HISTORIC AND DESIGN REVIEW COMMISSION

HDRC CASE NO: 2019-254
ADDRESS: 428 E MYRTLE
LEGAL DESCRIPTION: NCB 1752 BLK 5 LOT 17
ZONING: R-6,H
CITY COUNCIL DIST.: 1
DISTRICT: Tobin Hill Historic District
APPLICANT: Scott and Pam Carpenter
OWNER: Alfonso and Lisa Robalin
TYPE OF WORK: Exterior modifications
APPLICATION RECEIVED: April 30, 2019
60-DAY REVIEW: June 29, 2019
CASE MANAGER: Adam Rajper

**RE: 428 E Myrtle Street – Written Narrative for Final Approval for HDRC
Application and Certificate of Appropriateness – Window Replacement and
Restoration**

2 Proposed South Elevation

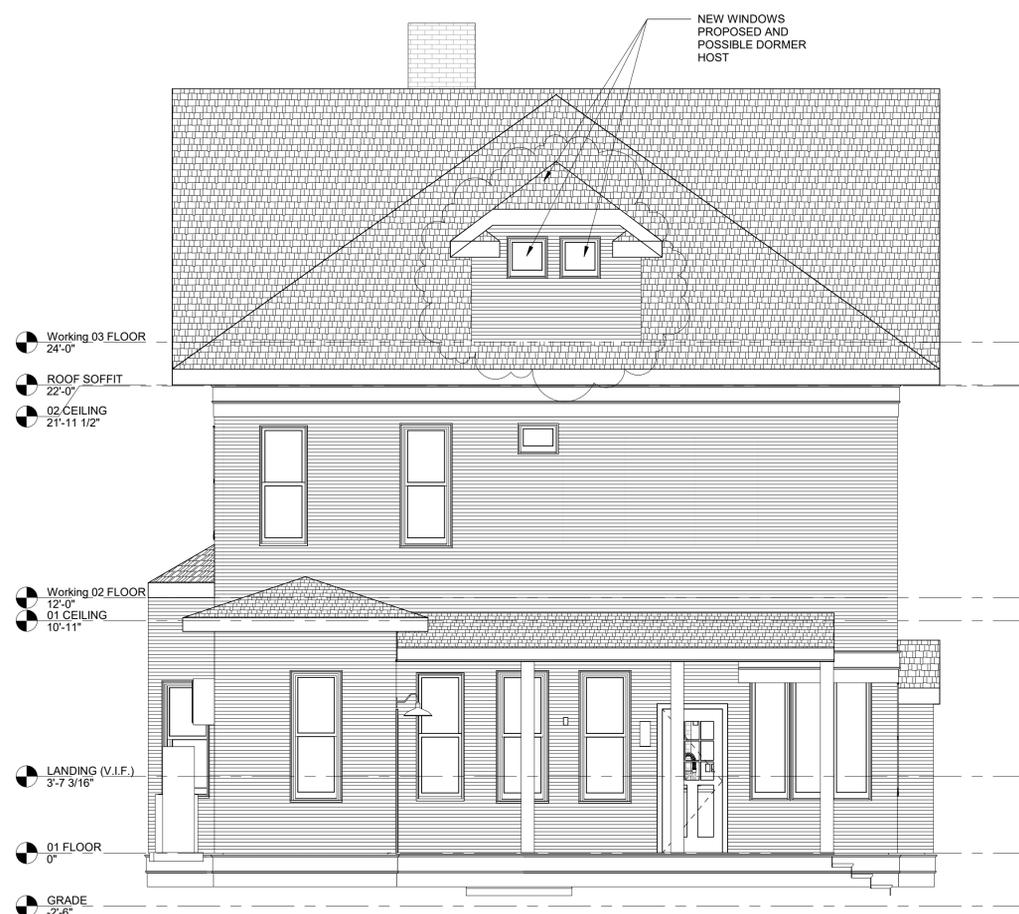
- WINDOW REPLACEMENTS** – The applicant has proposed to replace Window 1A on the first floor, as indicated on the submitted plans, as well as all existing windows on the side (east and west) elevations and rear (south) elevation, with Aluminum-Clad Wood Pella Windows. Staff conducted a site visit on April 23, 2019, and concurs with the applicant that these windows are either non-original or deteriorated beyond repair. According to the Historic Design Guidelines, replacement windows should match the historic windows in terms of size, type, configuration, material, form, appearance, and detail when original windows are deteriorated beyond repair. Replacement windows should also feature an exterior muntin pattern, profile, and size that is appropriate for the historic structure. Staff finds that these windows should be replaced with compatible windows, per the Guidelines.

Item 2 (Window Replacements), Staff recommends approval of the proposed window replacements, based on finding c, with the following stipulation:

- i. That the applicant submit final window specifications for the proposed replacement windows to staff for review and approval. Meeting rails must be no taller than 1.25” and stiles no wider than 2.25”. White manufacturer’s color is not allowed, and color selection must be presented to staff. There should be a minimum of two inches in depth between the front face of the window trim and the front face of the top window sash. This must be accomplished by recessing the window sufficiently within the opening or with the installation of additional window trim to add thickness. Window trim must feature traditional dimensions and architecturally appropriate sill detail. Window track components must be painted to match the window trim or concealed by a wood window screen set within the opening.

1 Proposed North Elevation

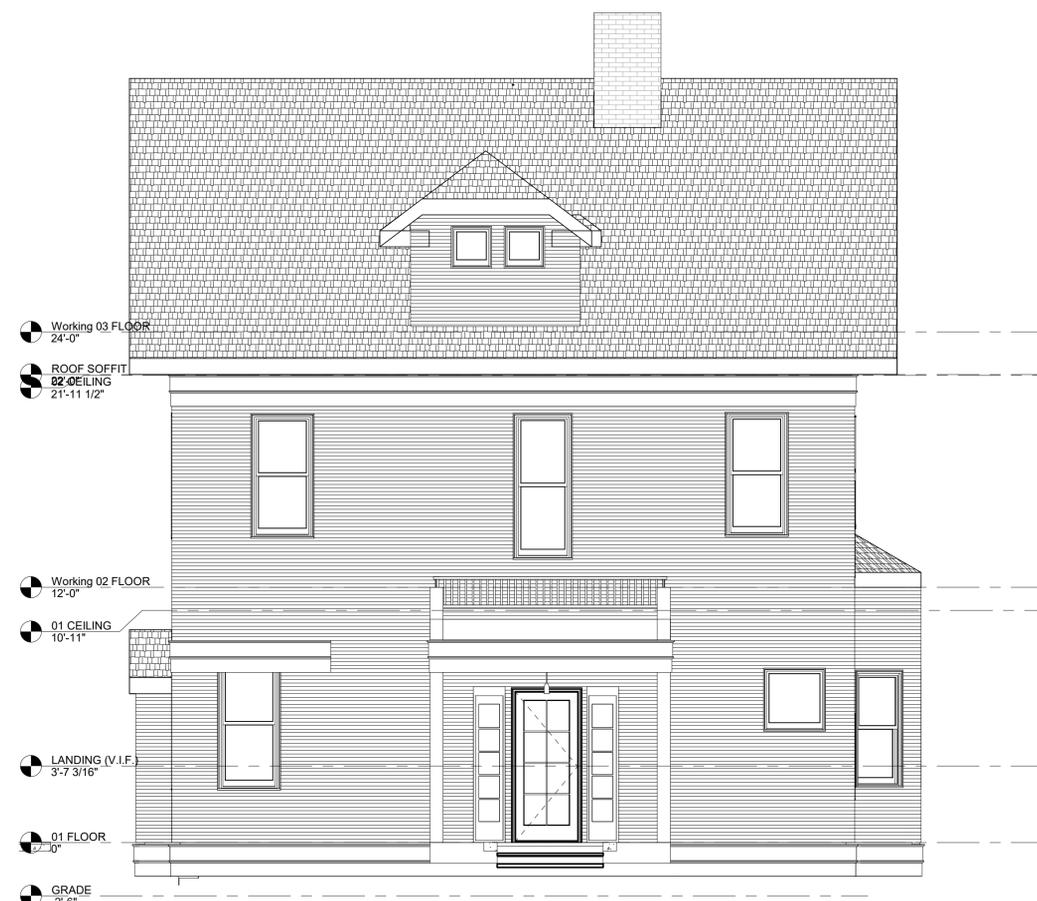
- WINDOW RESTORATIONS** – The applicant has proposed to restore all existing windows on the primary (north) elevation, with the exception of Window 1A on the first floor, as indicated on the submitted plans, which will be replaced. According to Guideline 6.A.iii for Exterior Maintenance and Alterations, historic windows should be preserved. Staff finds the proposal consistent with the Guidelines.

Item 1 (Window Restorations), Staff recommends approval of the proposed window restorations based on finding a and b.
